Replacement Requirement for Pressure Sensors for Refrigerant Circuit - Mixed Installation Not Permitted (70/24)

Vehicle Type: **Panamera 4 E-Hybrid (971)/Panamera 4S E-Hybrid (971)**

Model Year: **As of 2017 up to 2024**

Concerns: **Refrigerant circuit pressure sensors**

Pressure sensor part identifier

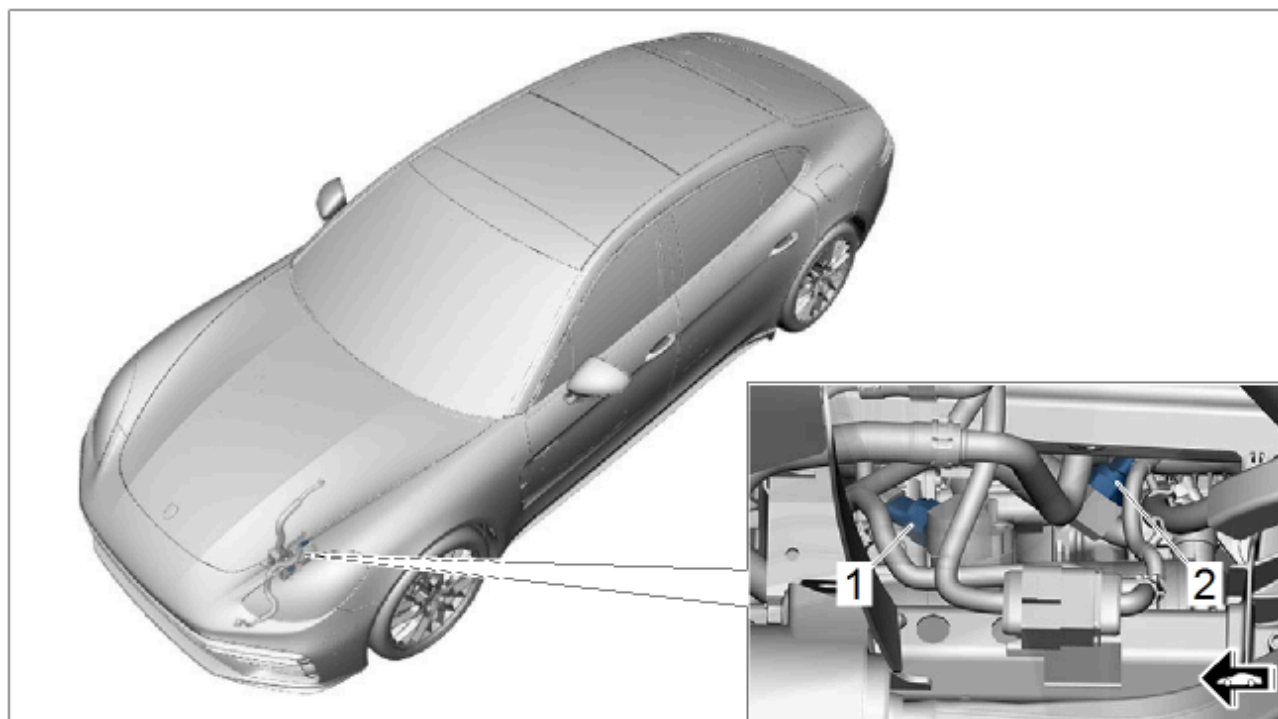
Cause: **Due to the discontinuation of an electronic component within the pressure sensor, the pressure sensors for the refrigerant circuit have been switched to a changed component status.**
 The changed component status can be identified by a changed part number.
 Pressure sensors that correspond to the changed component status are not compatible with the previous pressure sensors.
 If a pressure sensor is required for replacement, it must therefore be ensured that both pressure sensors in the refrigerant circuit correspond to the changed component status (identical part number). If this is not the case, the respective other pressure sensor must also be replaced as a one-off. Mixed installation of pressure sensors with different component status (mixed installation) is not technically permissible and leads to faults in the refrigerant circuit and in the air conditioning.

- 1 – Pressure sensor part identifier

Action: If a pressure sensor must be replaced, ensure that both pressure sensors in the refrigerant circuit correspond to the changed component status with the part identifier 4M0959603J.

If this is not the case, **both** pressure sensors must be replaced.
